PlanGrid Task Report - Feb 14, 2025

L05590 Ogden & Iroquois (IL) FSU

1159 East Ogden Avenue, Naperville, Illinois

IMG_4970

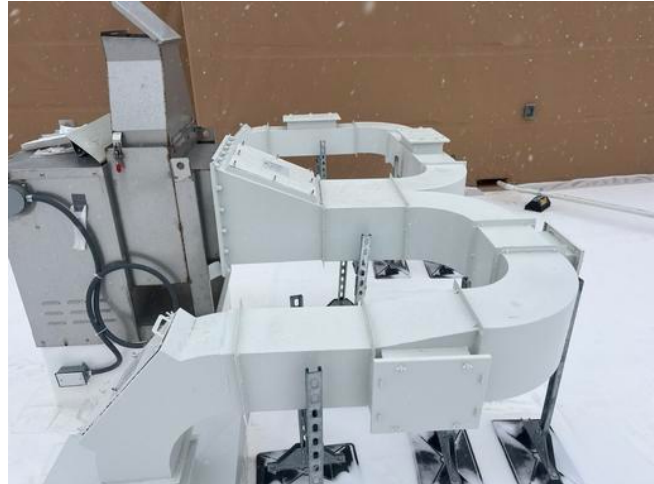
CORRECT number of access doors installed, and doors installed in approximate locations. In instances on both fans, cleanout doors do not meet sizing specification. Additionally, some doors installed on top of duct. Appears these changes were made to accommodate supports as well as adjustments made to MC constructed duct length due to position of fan and duct penetrations. Fans are both operating at design and within design static pressure. SEEK APPROVAL.
